Access Compliance Report Public Rights-of-Way (Curb Ramps)

Intersection ID: 43093 Main Street: N POPLAR ST Cross Street: W 10TH ST Location:

ADA ID: EAFC28CB448E Ramp Type: PerpDiag Initial Pass/Fail: Fail **Overall Compliance: No** Severity Score: 33.75

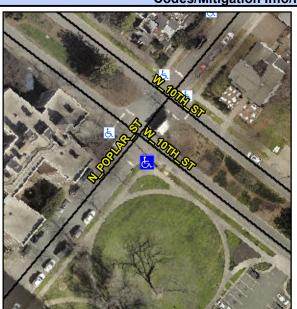
Not Found, R304.5.1, R304.2.2

Compliance Description Da		Data	Compliance Description		Data
N/A	Ramp Length (in)	57.0	No	Ramp Slope (%)	12.8
No	Ramp Width (in)	37.0	Yes	Ramp XSlope (%)	0.3
N/A	Flare Type LT	N/A	N/A	Flare Type RT	N/A
N/A	Flare Slope LT (%)	N/A	N/A	Flare Slope RT (%)	N/A
N/A	Flare Traversable LT?	N/A	N/A	Flare Traversable RT?	N/A
N/A	Landing Length (in)	N/A	N/A	DWS Provided?	N/A
N/A	Landing Width (in)	N/A	N/A	DWS Contrast?	N/A
N/A	Landing Slope (%)	N/A	N/A	DWS Length (in)	N/A
N/A	Landing X Slope (%)	N/A	N/A	DWS Full Width?	N/A
N/A	Landing Curb? (Y/N)	N/A	N/A	DWS Offset (in)	N/A
N/A	Shared Landing?	N/A			
N/A	Gutter Ponding?	N/A	N/A	Gutter Slope (%)	N/A
N/A	Gutter Lip Ht (in)	N/A	N/A	Gutter X Slope (%)	N/A
N/A	Painted X Walk1?	No	N/A	Painted X Walk2?	No
	X Walk 1 Direction	To NE		X Walk 2 Direction	To NW
N/A	X Walk 1 Width (in)	N/A	N/A	X Walk 2 Width (in)	N/A
	X Walk 1 Slope (%)	8.1		X Walk 2 Slope (%)	4.2
	X Walk 1 X Slope (%)	1.1		X Walk 2 X Slope (%)	3.7

Possible Solutions: Remove & Replace Curb Ramp With **Two New Directional Ramps or** Equivalent. Surveyor Notes: N/A PROW/ADA:
